**THE UNITED STATES OF AMERICA
BEFORE THE
FEDERAL ENERGY REGULATORY COMMISSION**

Martin County Solar Project, LLC

**Docket Nos. ER25-2335-000
ER25-2335-001**

**MOTION FOR LEAVE TO ANSWER AND
ANSWER OF PJM INTERCONNECTION, L.L.C.**

Martin, Martin II and Martin BESS Shared Facilities

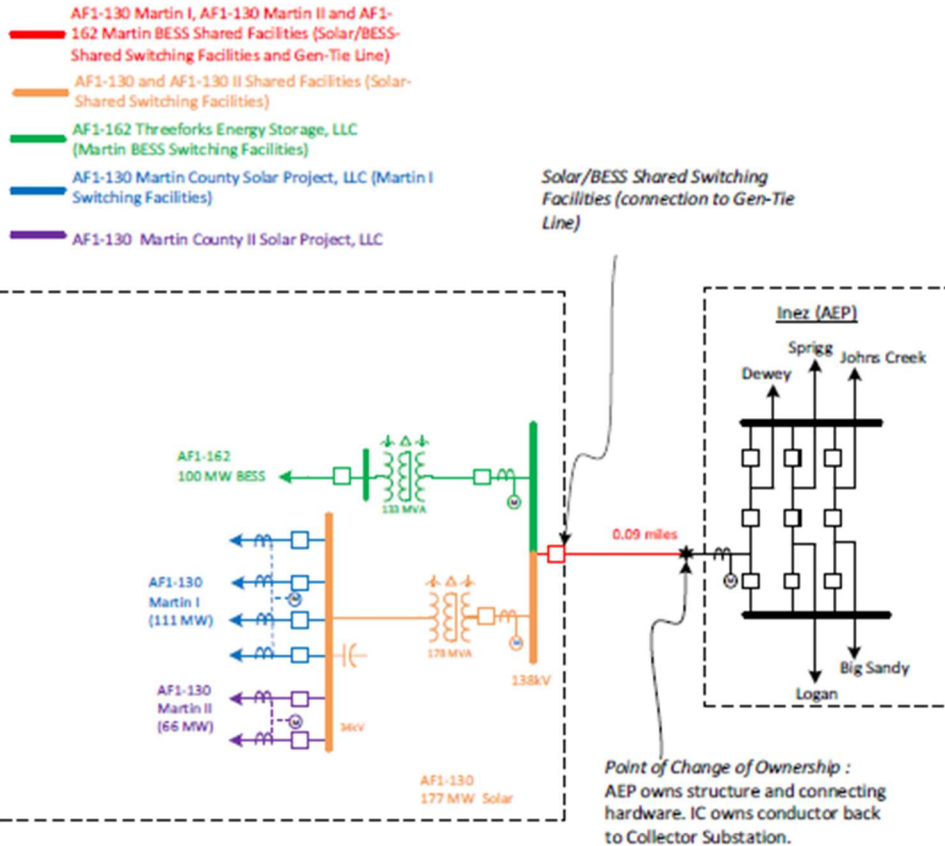
The jumble of facilities listed in Recital M of the SFA seems to describe multiple sets of ICIF under different ownership arrangements, but the JOU cannot have more than one set of discrete, sole-use, radial, jointly owned ICIF, which is a directed line extending from the JOU to the Point of Change of Ownership ("PCO"). Moreover, the SFA and Deficiency Response incorrectly suggest that the "Gen-Tie Line," shown in red in the graph below,²⁰ is the only shared ICIF.

As explained in PJM’s July 18 Answer, the JOU’s sole-use radial ICIF comprise all facilities beginning at the high-voltage sides of the JOU’s two main power transformers (“MPTs”), and extending to the PCO with the Transmission Owner Interconnection Facilities. In other words, the SFA *should* describe the shared facilities as all high-voltage facilities between the MPTs and the PCO, but it does not. Accordingly, Martin County Solar has failed to accurately respond to the Deficiency Letter.

For the reasons stated above, and in the June 18 Protest and July 18 Answer, PJM respectfully asks the Commission to direct the Parties to (1) modify the Shared Facilities Agreement to be consistent with the Parties' obligations under their respective service agreements, and (2) clarify the scope of shared jurisdictional ICIF under the Shared Facilities Agreement.
